**Design Addendum**

For Reselton Properties

This Design Addendum has been prepared in direct response to a series of comments provided by London Borough of Richmond Upon Thames regarding the submitted proposals for the former Stag Brewery site in Mortlake.

Block 1 (cinema) - Proposed south elevation

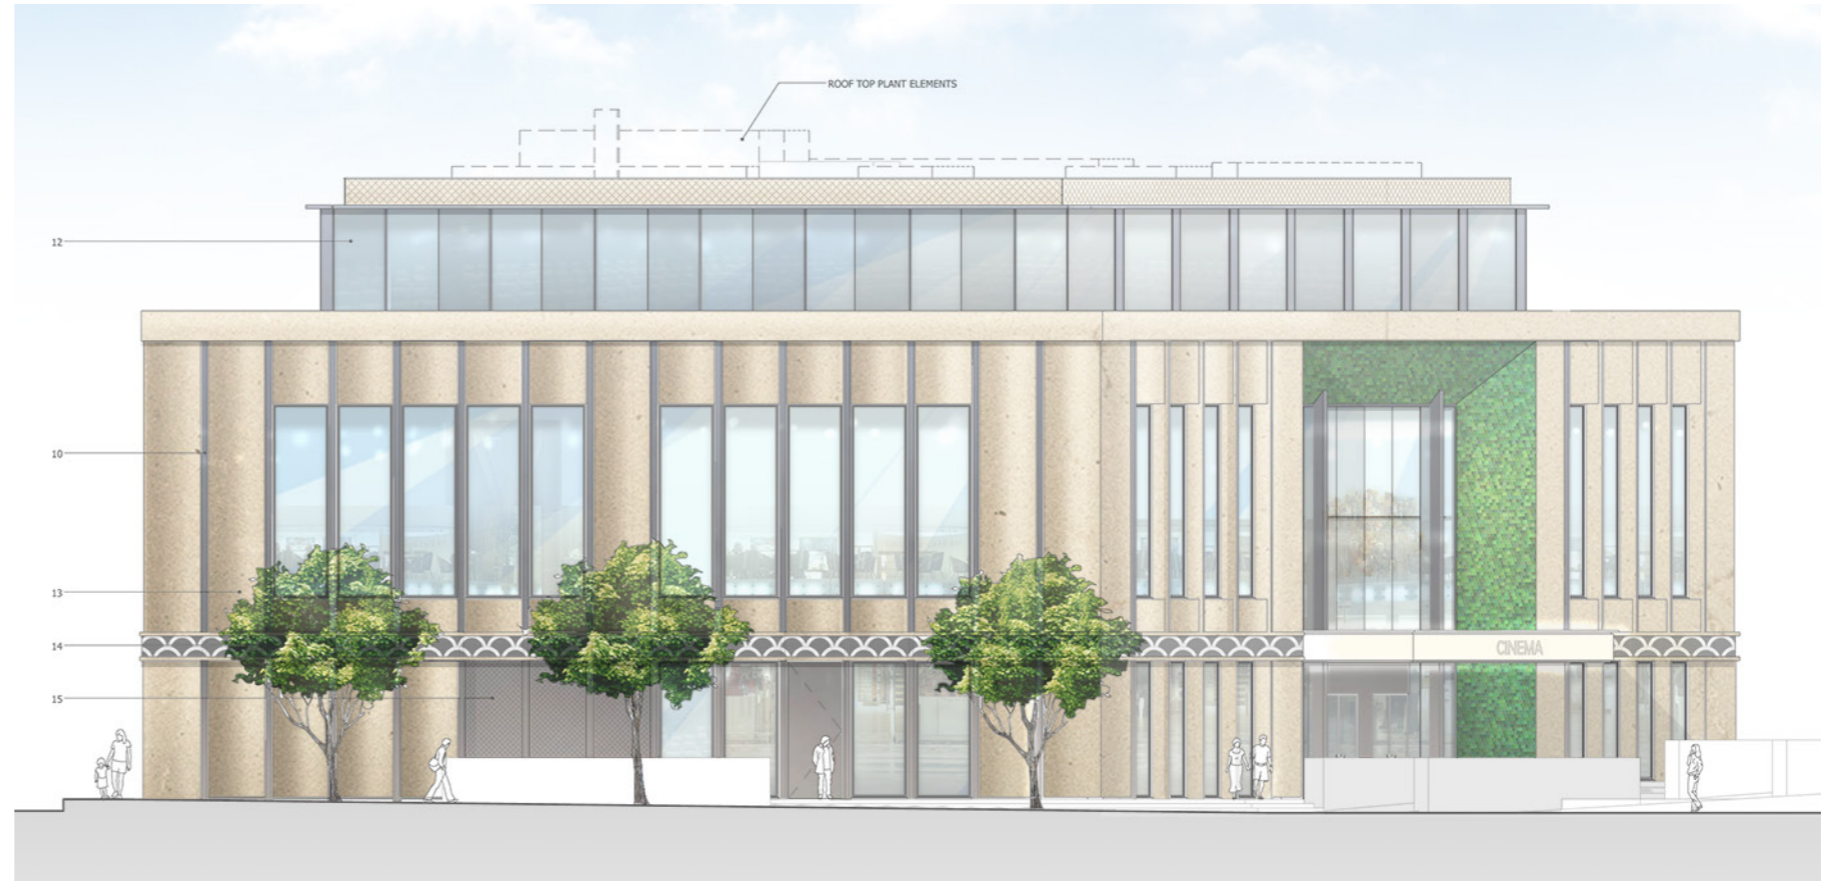
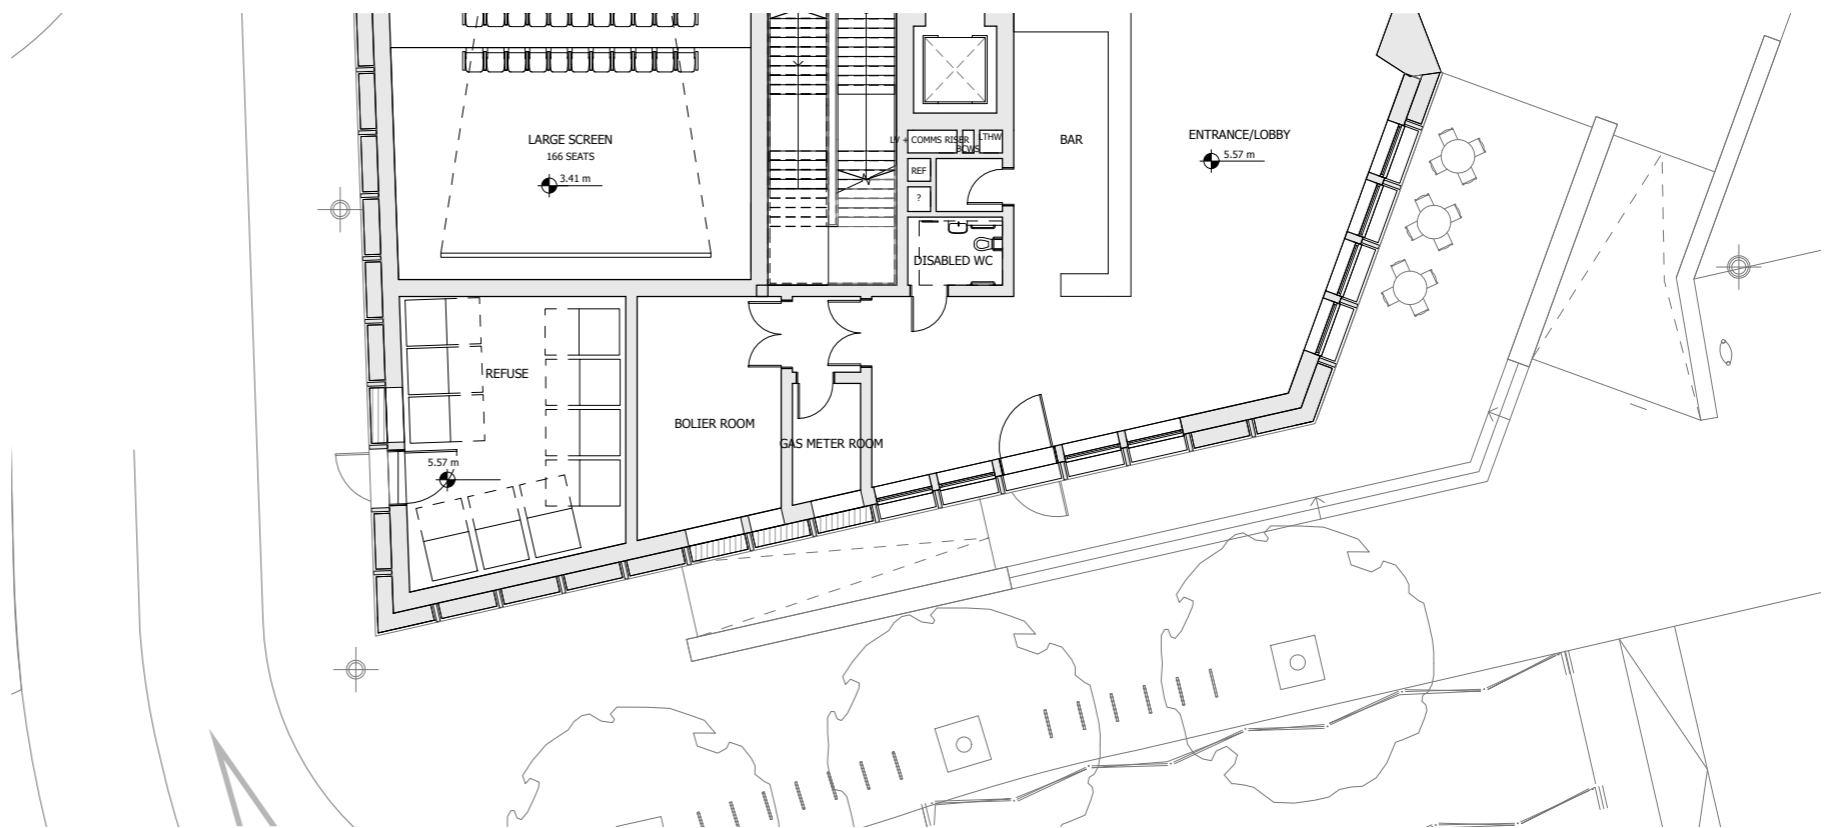
13. South elevation has a poor relationship with street: Refuse, boiler, second entrance.

14. As mentioned in earlier paragraphs, the cinema screens have been arranged to avoid overlooking issues with residential buildings opposite. These screen occupy most of the North and West facades. This leaves very little opportunity for the incorporation of refuse store and boiler rooms - which must have direct access from the street. The refuse cannot be collected from Lower Richmond Road since this would cause disruption to traffic. It is for this reason that it has been positioned on the corner of Ship Lane. The boiler room requires ventilation and must be positioned on a facade - it must also be positioned in a location where the flue can terminate in the set back rooftop level and so that service routes can be distributed easily to both cinema screens. It is for this reason that the North facade was discounted as a suitable location.

Proposed typical floor plan - Buildings 2 and 3

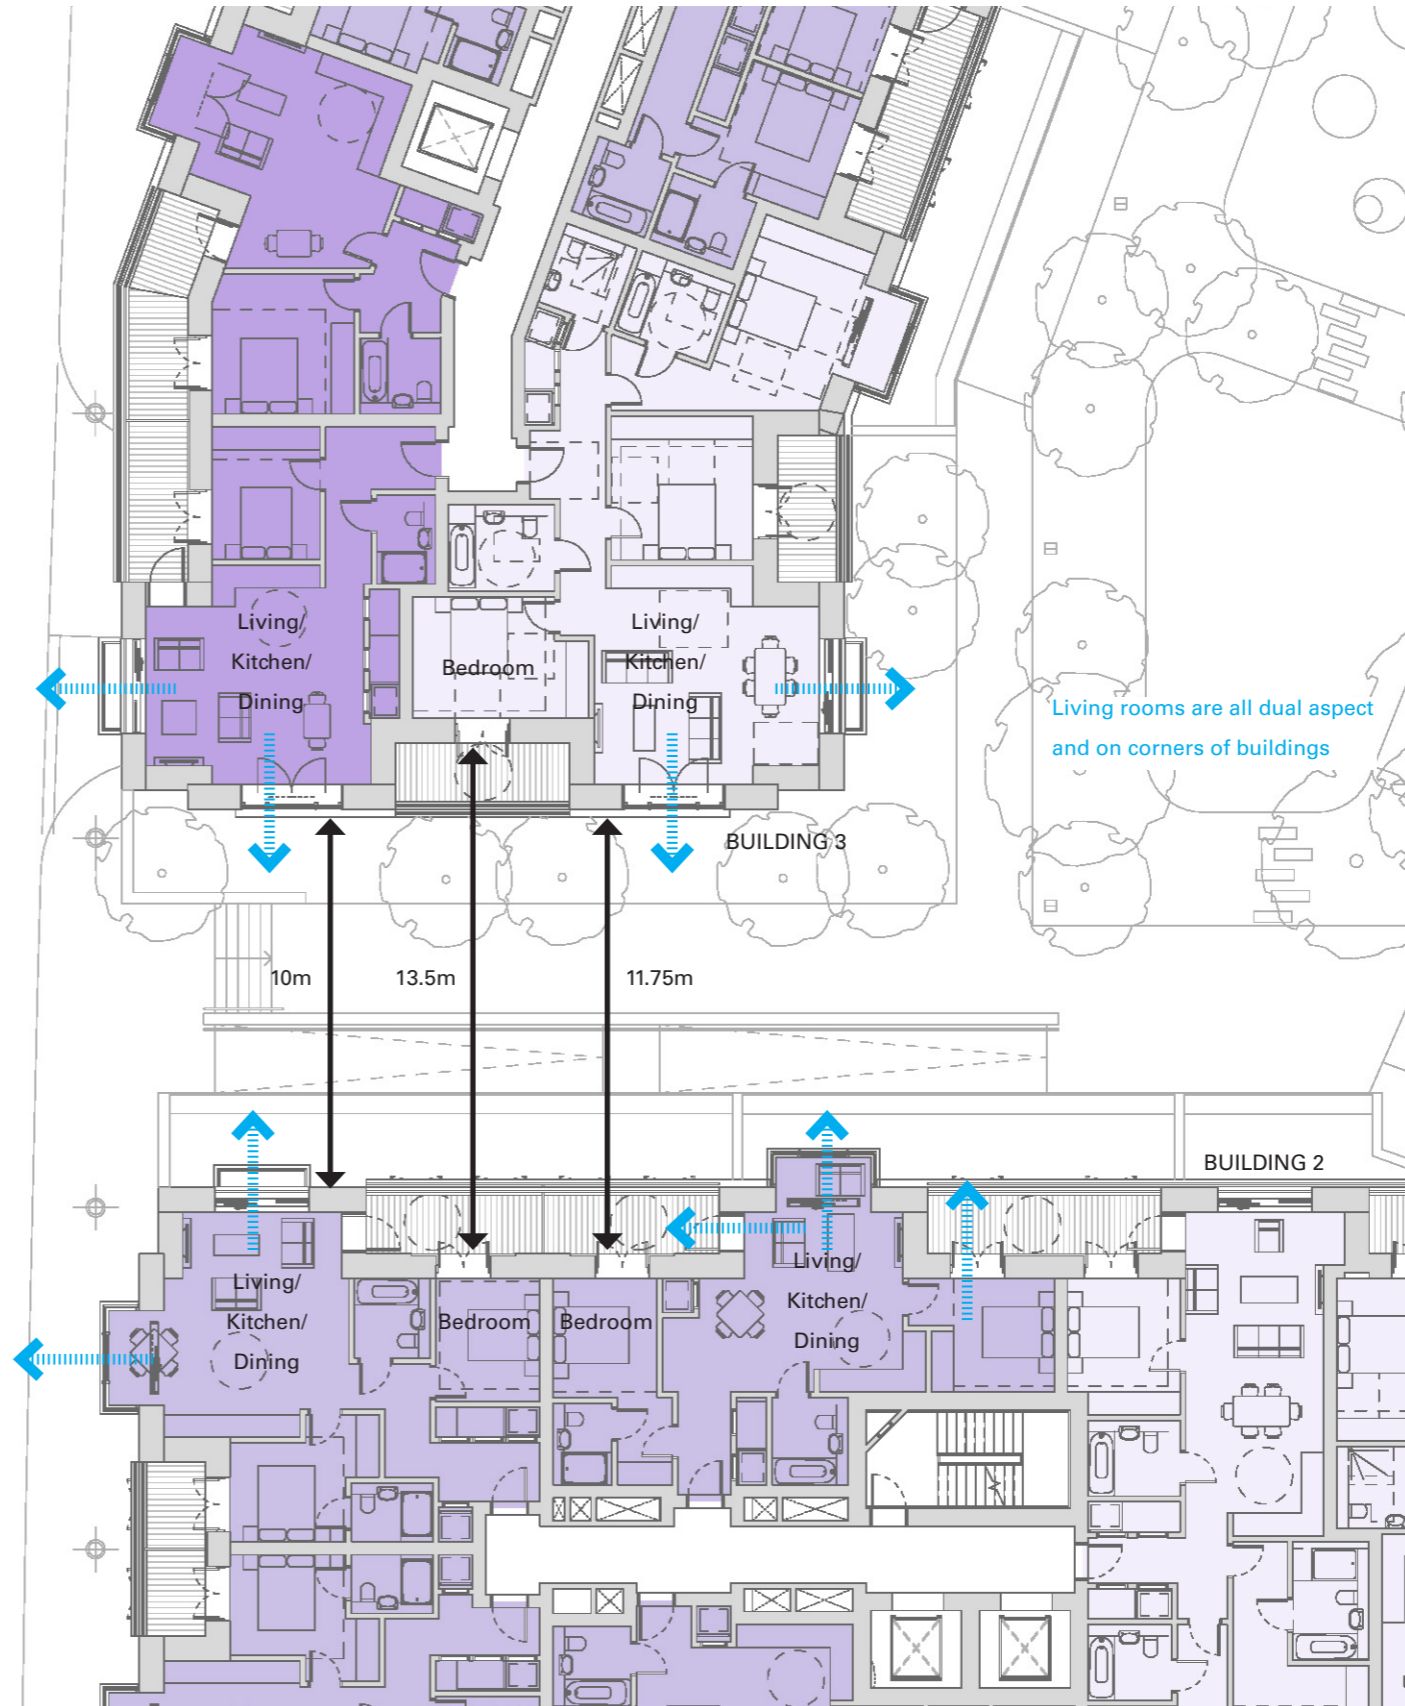
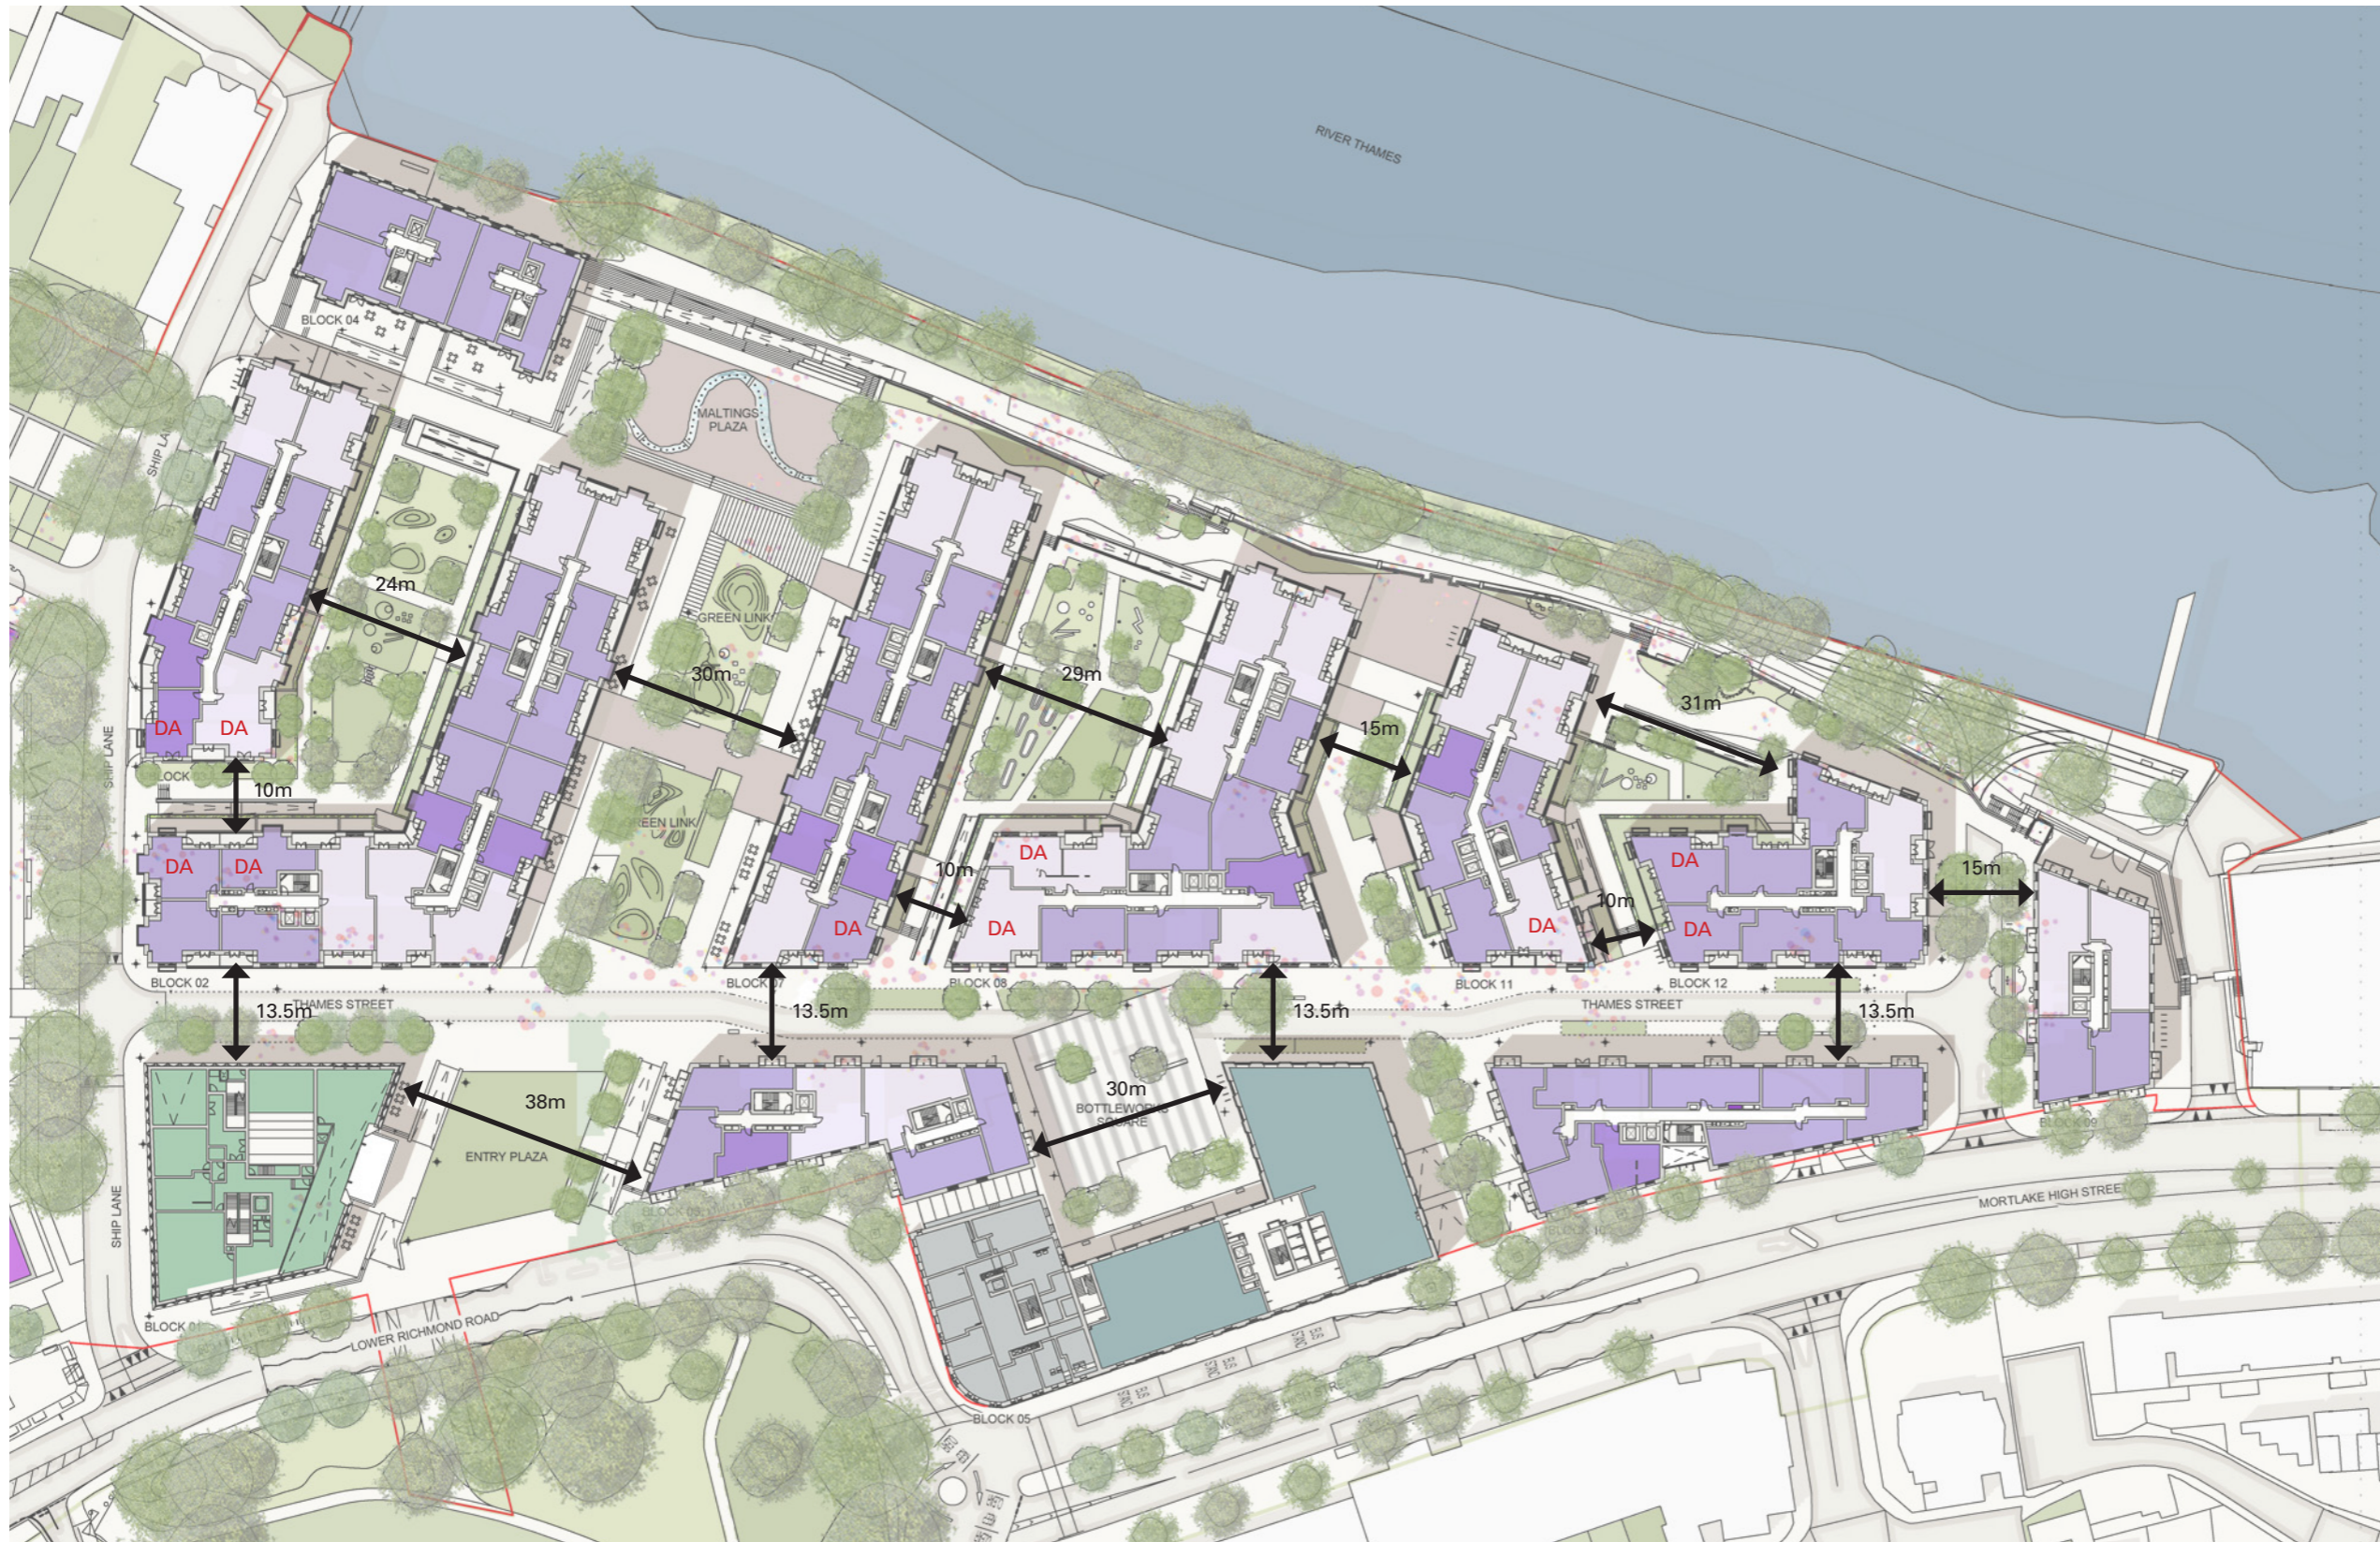
- 4. Block 2 with Block 3: North facing, single aspect, only a 10m distance (and 12m on upper floors) - unacceptable living conditions.
- 5. Block 2 with Block 1: only 13m separation.

Please see section dedicated to 'Proximity of Buildings'.
